The Sir Robert Ogden Evans Property Partnership Ltd
Proposed Residential Development, Dunningley Lane, Tingley

Stage One Road Safety Audit Designer's Response

4 December 2017
Version 1.0
Issue

Drawn by	Checked by	Date	Scale	Format
VP	AS	04.12.2017	AS SHOWN	A1
Job Number	Drawing Number	Revision		
3103	3103 SK003 004	B

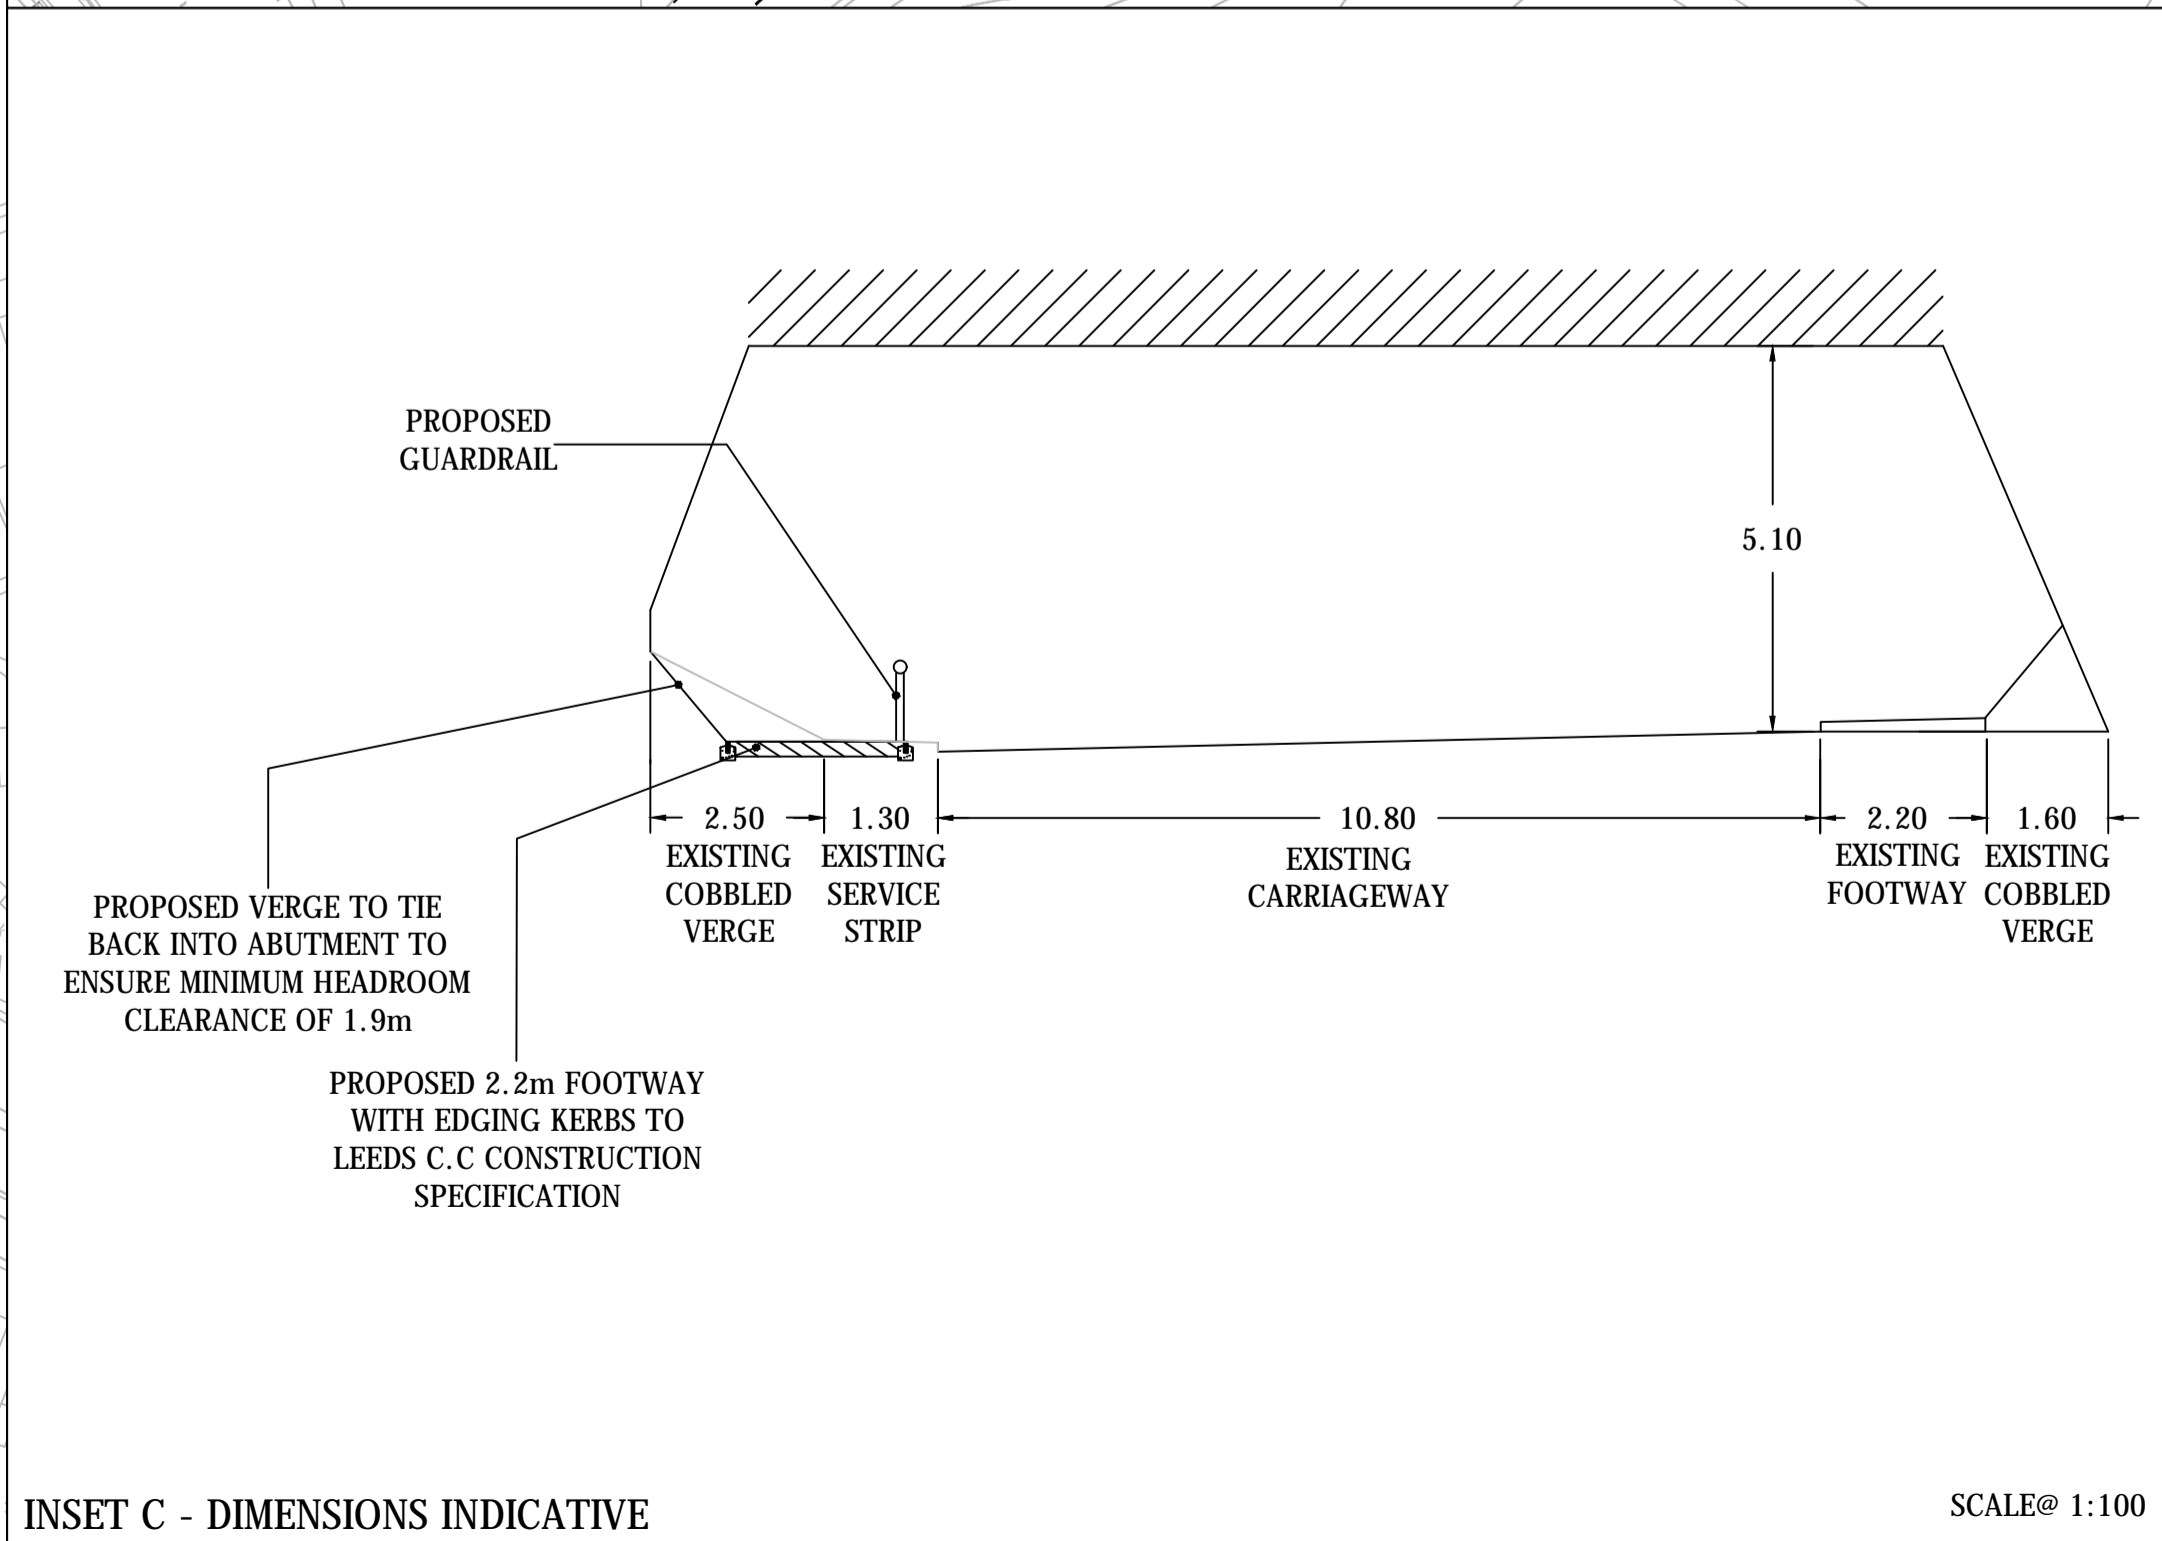
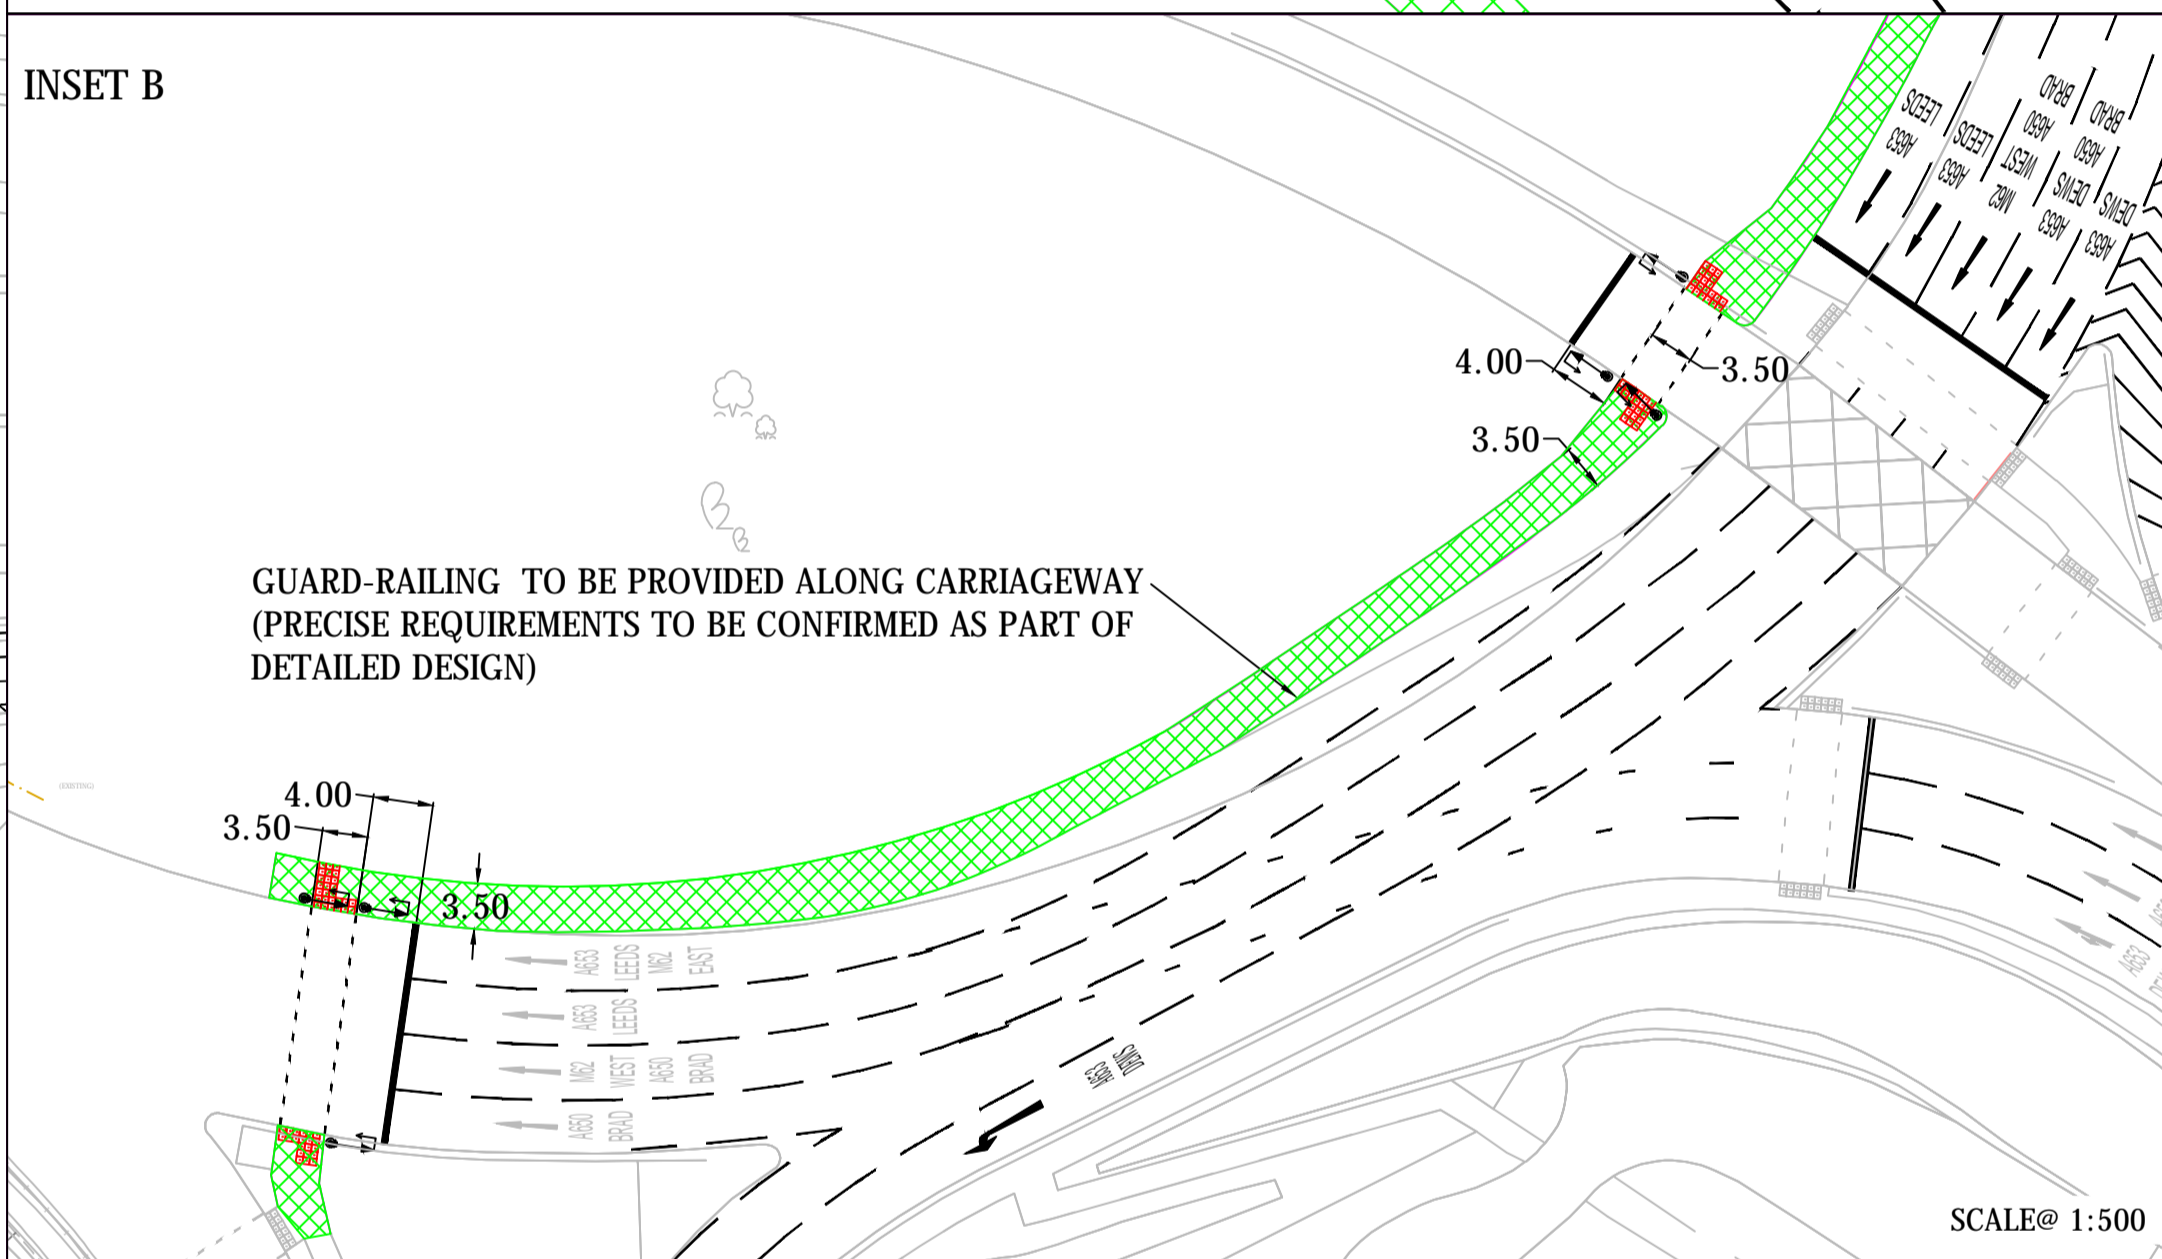
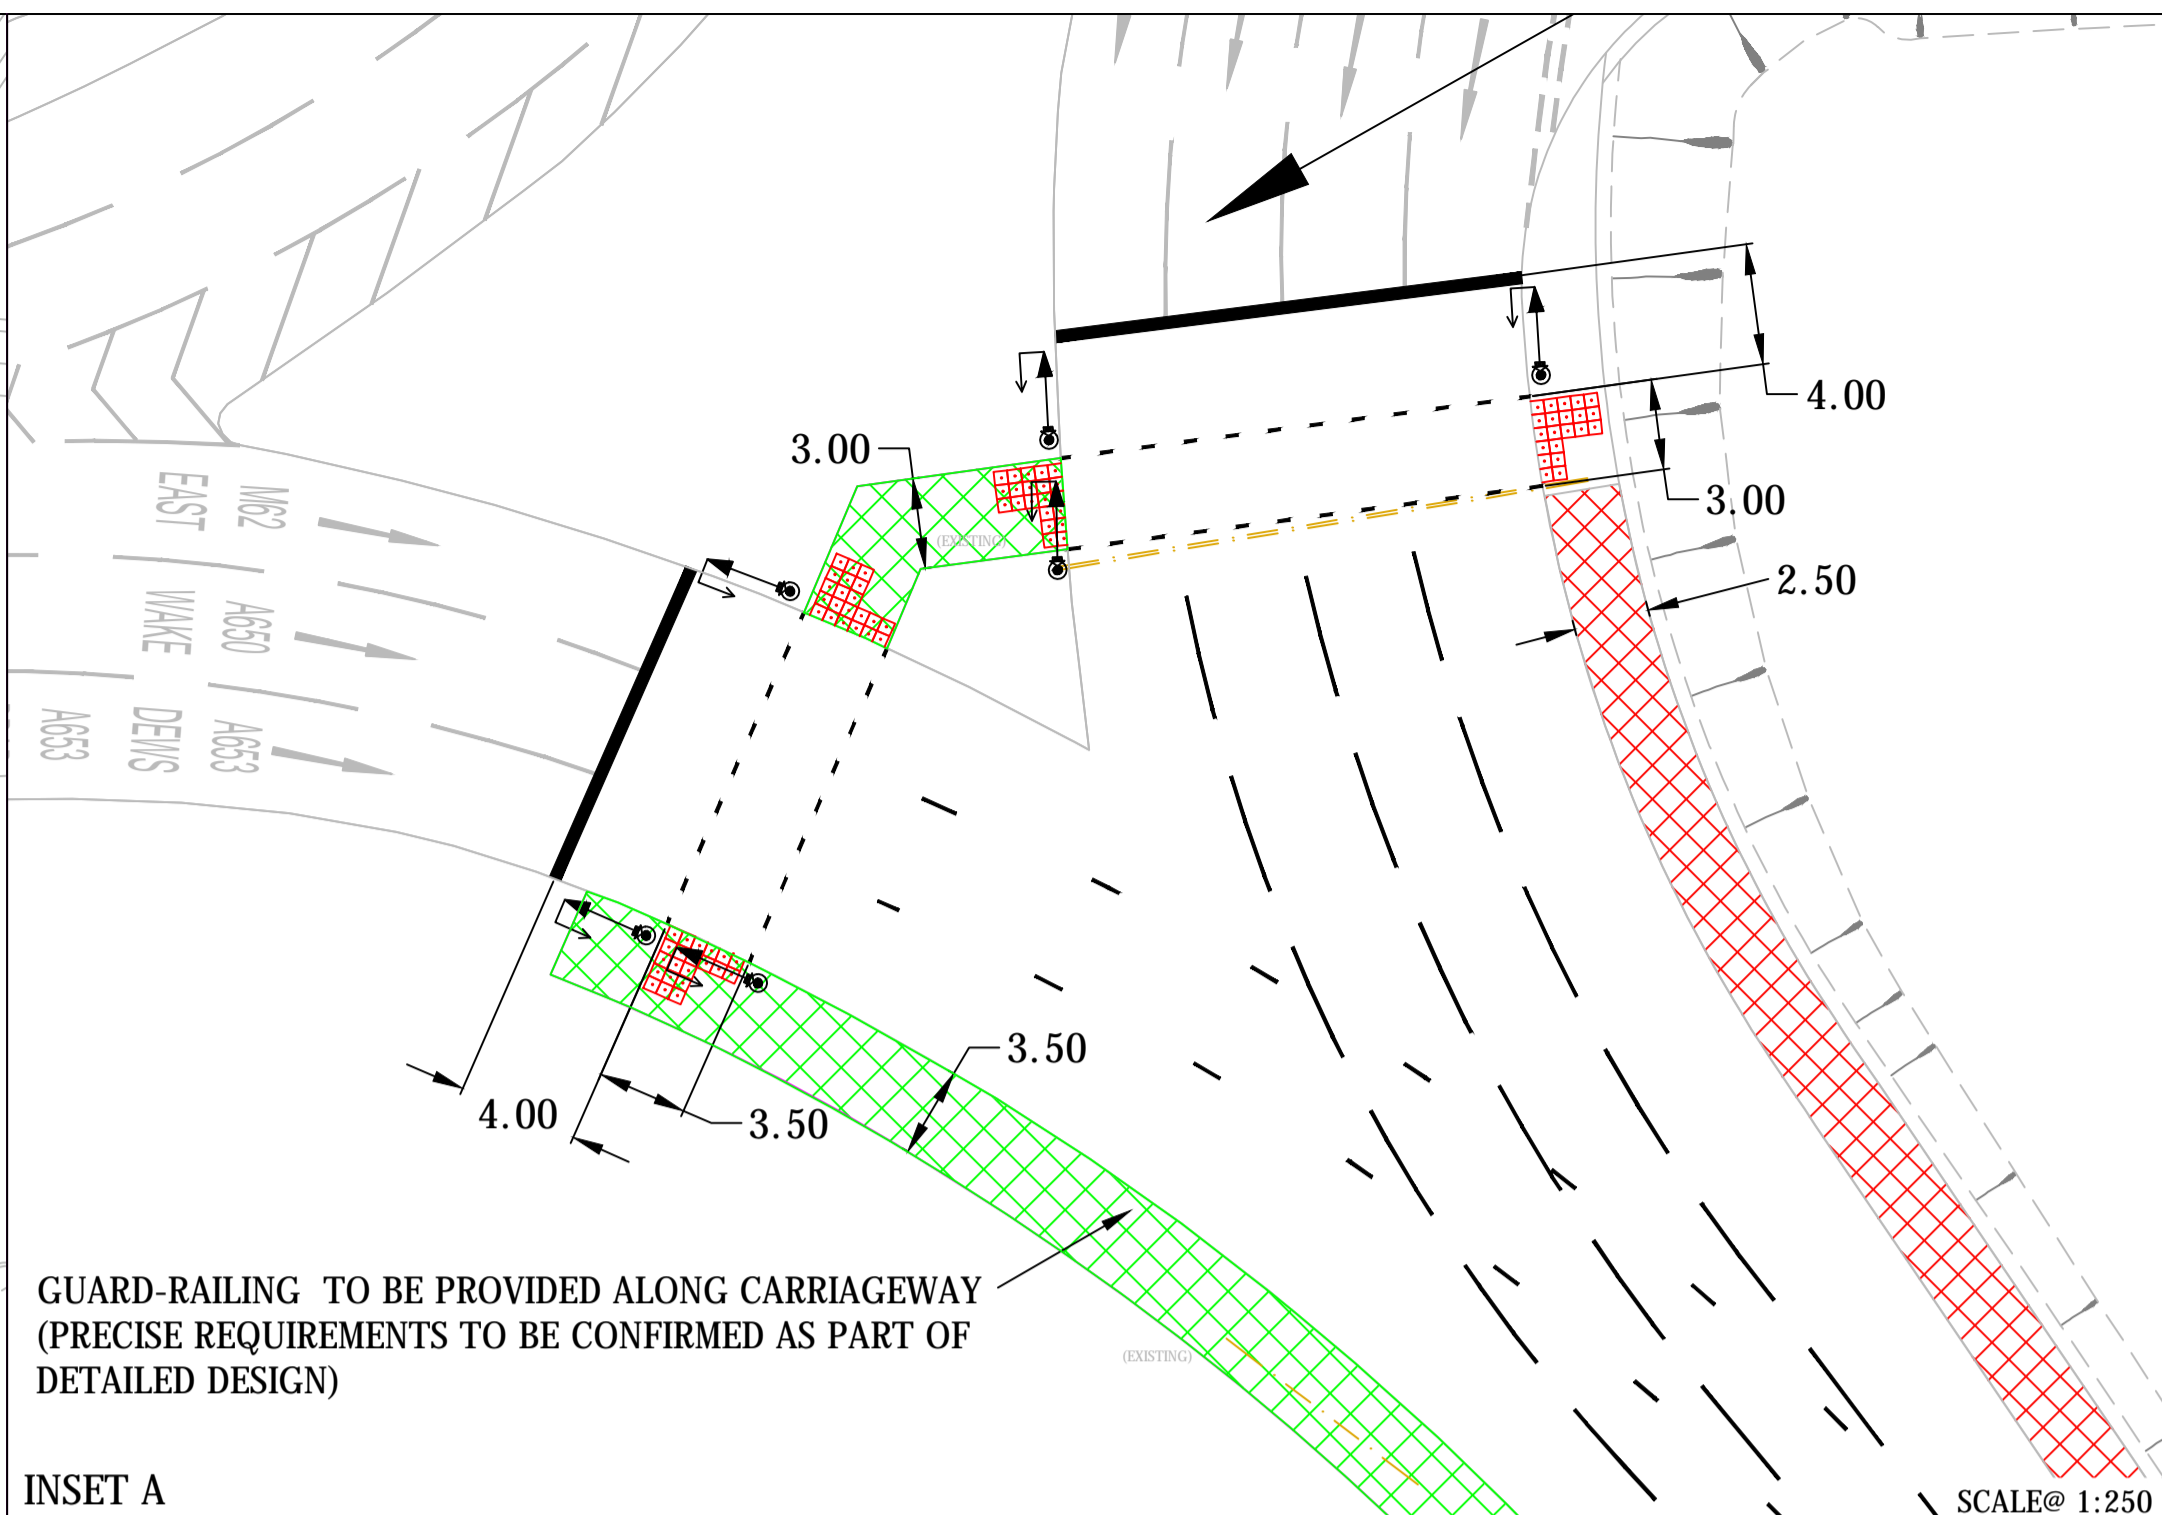
Location:	M62 Junction 28 interchange
Summary:	Pedestrian / cycle route through the interchange safety issues
Description:	<p>The current and proposed cycle / pedestrian facilities through the interchange both involve pedestrians and cyclists travelling adjacent to the carriageway, crossing several lanes of traffic via signalised facilities. At present the facilities appear to be used infrequently by pedestrians and cyclists; however, once the development is built and children are using it to reach both the Primary School and the Academy, including children in groups, there is an increased risk of exposure to fast moving traffic using the interchange. Although some improvements / upgrades are proposed to the facilities for pedestrians and cyclists around the junction, given the envisaged large increases in pedestrian / cycle flows there is an increased risk of these groups being struck by motor vehicles with resulting injuries. In addition, there is a chance that the route will become slippery due to leaves falling from the numerous trees on the roundabout's central island.</p>

Location:	Interchange central island
Summary:	Location of proposed pedestrian /cycle facility on the central island not on desire line
Description:	<p>The proposed pedestrian /cycle facility is intended to be located on the central island for most of its route to avoid users having to cross the M62 slip roads. However, the Team considered that there may be reluctance for users to do this as crossing on to the central island may not be the natural desire line. Users may elect instead to try and use the route of the existing facilities. As the existing crossing points would now be uncontrolled (notwithstanding any anti-pedestrian surfaces / barriers which may be provided to prevent access) this would bring them into conflict with vehicles using the slip roads. Also, the present arrangement involves crossing a maximum of three traffic lanes at any one point, the proposed arrangement involves crossing five lanes of the circulatory carriageway increasing the risk of exposure to contact with vehicles and subsequent injury to cyclists / pedestrians, particularly when crossing in groups. Finally, there is the potential for signal failure which would mean pedestrians / cyclists having to cross the circulatory carriageway through moving traffic with an increased risk of contact and injury.</p>

The revised preliminary layout is demonstrated on Fore Consulting drawing 3103/SK003/004B, incorporating allowance for guardrailling adjacent the kerbside, while retaining a footway / cycleway width of 3.0m. The precise guardrailling requirements will be addressed as part of the detailed design process.

The revised preliminary layout is demonstrated on Fore Consulting 3103/SK003/004B, incorporating allowance for guardrailings adjacent the kerbside (while retaining a footway / cycleway width of 3.0m).
